Camden Town Hall

Implications of heritage doors not being upgraded on the fire strategy

Basement - Door Coordination Plan
Heritage Fire Doors

CTH-PUR-B0-DR-31-A-5600

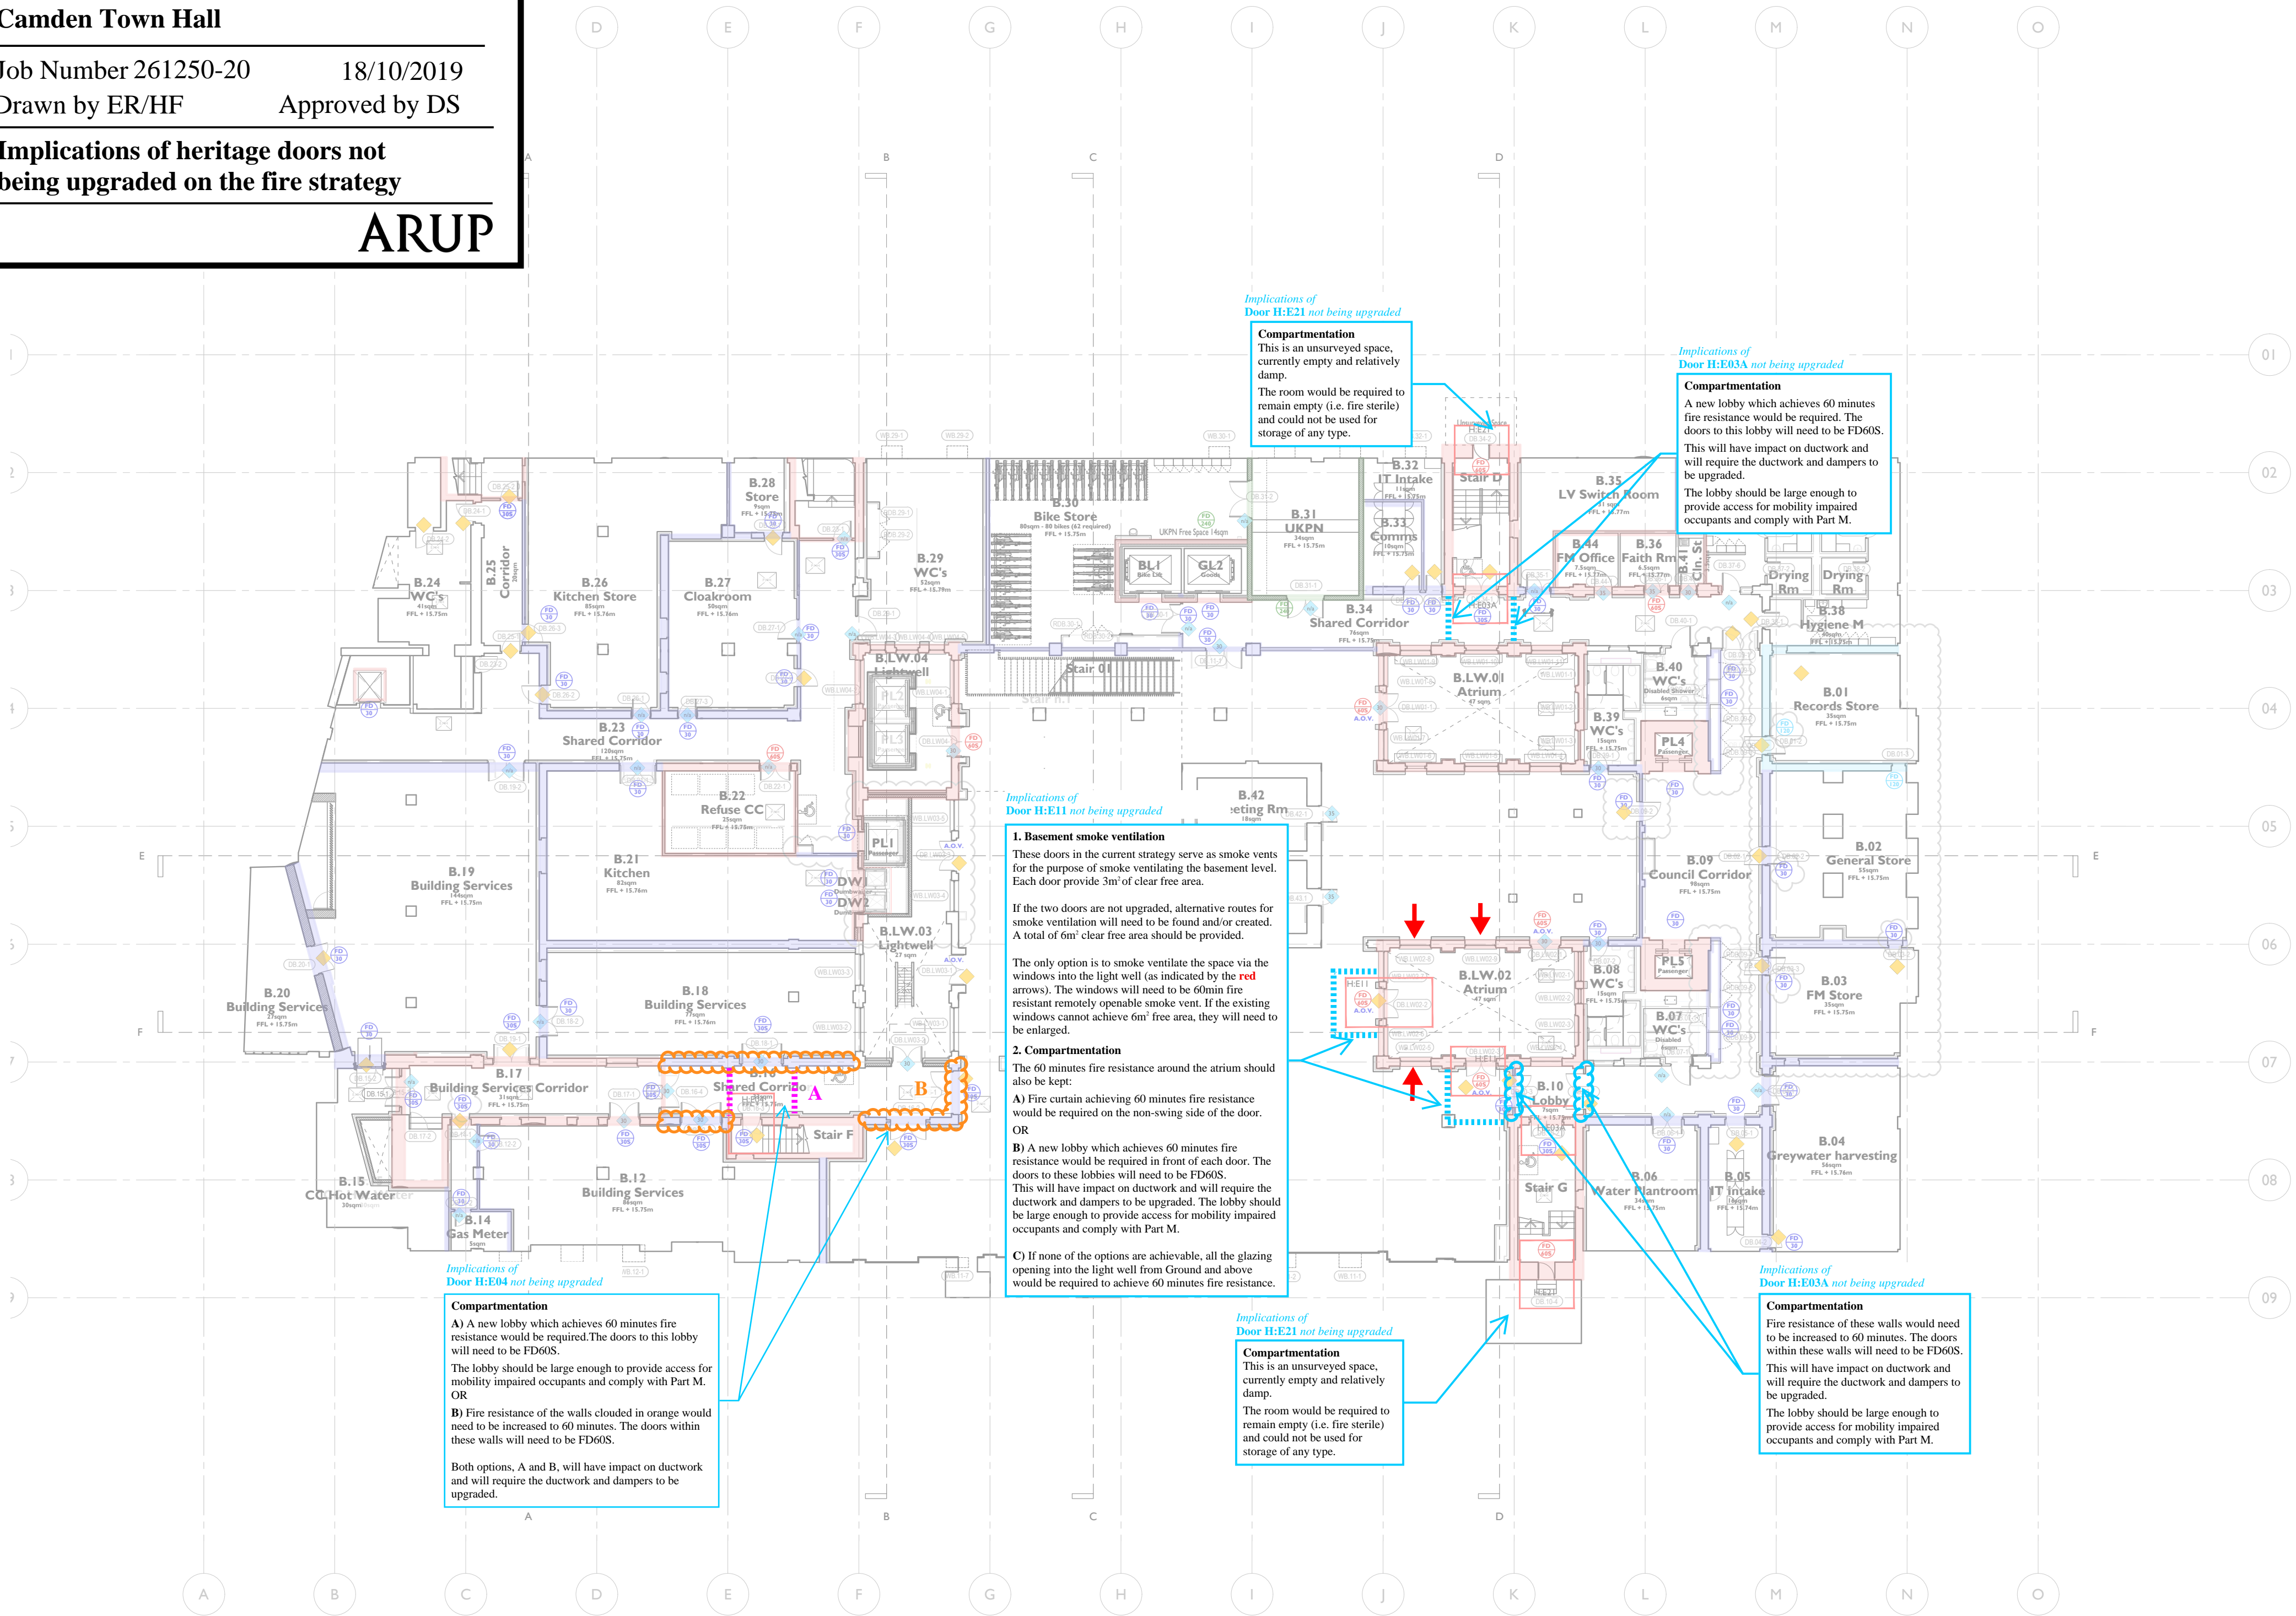
Access notes from Jane Toplis mark-up of 30.07.19	
01	Assume always open when building open.
02	Assume manual opening.
03	Assume no automation.
04	Council policy on automatic door to meeting room. Nice to have.
05	Council policy on automating doors to accessible WC cubicles.
06	Preferable if completely new door has 750mm clear width through one open leaf
07	Prefer single door 900mm clear width automated.
08	Assumed Camden Centre tenant will have managed means of escape procedure.
09	Not in use.
10	Doors currently left open. If they are closed in future (as per security strategy) they need automation.
11	Council to reconfirm that only side doors being automated is acceptable (I understand main central door is difficult to automate.
12	Council to confirm it is acceptable for there to be management strategy to assist wheel chair user to access wheel chair refuge, or automate doors.
13	Tenant needs to have management strategy to open door or automate.

14	Not in use.
15	Can these doors be removed?
16	Automatic doors on activation of fire alarm. Purcell to confirm details of doors for comments on accessibility.
17	These new double doors are too narrow. Can they be 1.5 or 1 door leaf?
18	These doors need to be automated, to assist wheel chair users reaching refuges, or management strategy required.
19	Not in use.
20	Should platform lift doors be fire rated?
21	Not in use.
22	Not in use.
23	Not in use.
24	Not in use.
25	Need to see details of terraces.
26	Not in use.
Acoustic Key	
	Acoustic rating for newly proposed door, Rw30
	Acoustic rating for newly proposed door, Rw35
	Acoustic rating for newly proposed door, Rw40
	Newly proposed door, no acoustic rating required
	Doorset retained (Pending review)
	Recommended 35Rw
	Recommended 40Rw

DRAWING NO. CTH-PUR-G0-DR-31-A-5601

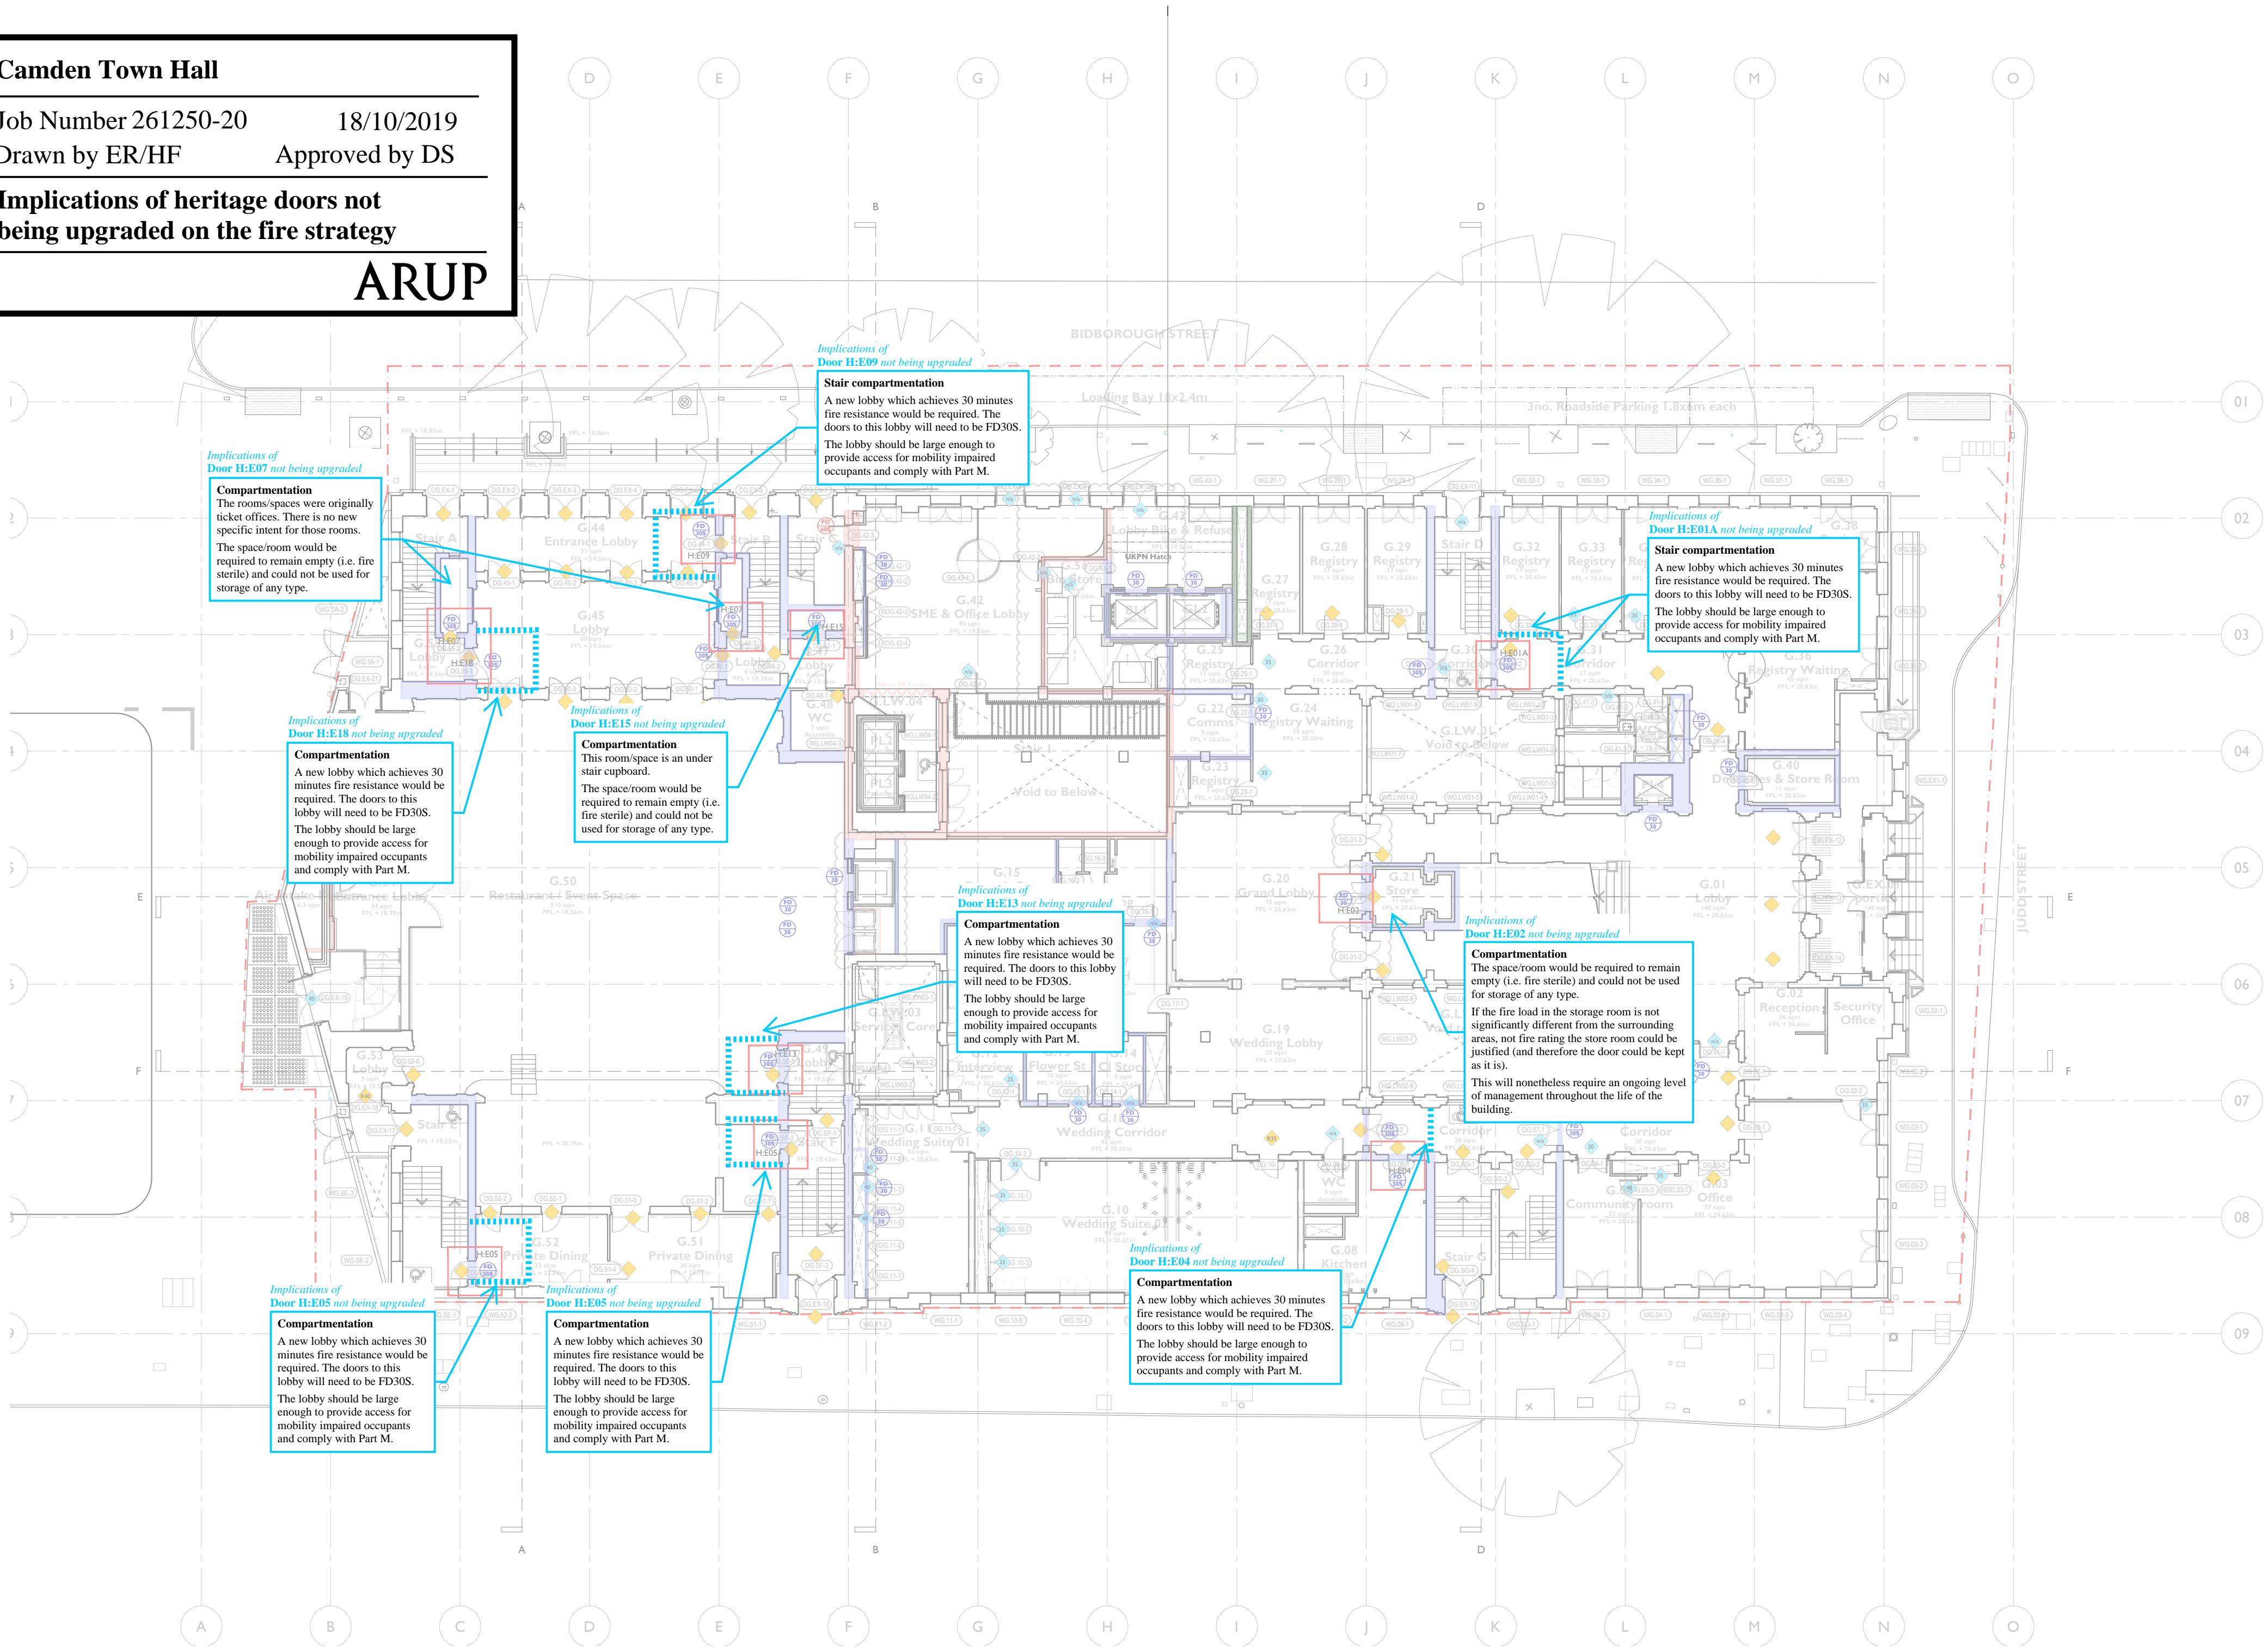
Access notes from Jane Toplis mark-up of 30.07.19	
01	Assume always open when building open.
02	Assume manual opening.
03	Assume no automation.
04	Council policy on automatic door to meeting room. Nice to have.
05	Council policy on automating doors to accessible WC cubicles.
06	Preferable if completely new door has 750mm clear width through one open leaf
07	Prefer single door 900mm clear width automated.
08	Assumed Camden Centre tenant will have managed means of escape procedure.
09	Not in use.
10	Doors currently left open. If they are closed in future (as per security strategy) they need automation.
11	Council to reconfirm that only side doors being automated is acceptable (I understand main central door is difficult to automate.
12	Council to confirm it is acceptable for there to be management strategy to assist wheel chair user to access wheel chair refuge, or automate doors.
13	Tenant needs to have management strategy to open door or automate.

14	Not in use.
15	Can these doors be removed?
16	Automatic doors on activation of fire alarm. Purcell to confirm details of doors for comments on accessibility.
17	These new double doors are too narrow. Can they be 1.5 or 1 door leaf?
18	These doors need to be automated, to assist wheel chair users reaching refuges, or management strategy required.
19	Not in use.
20	Should platform lift doors be fire rated?
21	Not in use.
22	Not in use.
23	Not in use.
24	Not in use.
25	Need to see details of terraces.
26	Not in use.
Acoustic Key	
	Acoustic rating for newly proposed door, Rw30
	Acoustic rating for newly proposed door, Rw35
	Acoustic rating for newly proposed door, Rw40
	Newly proposed door, no acoustic rating required
	Doorset retained (Pending review)
	Recommended 35Rw
	Recommended 40Rw
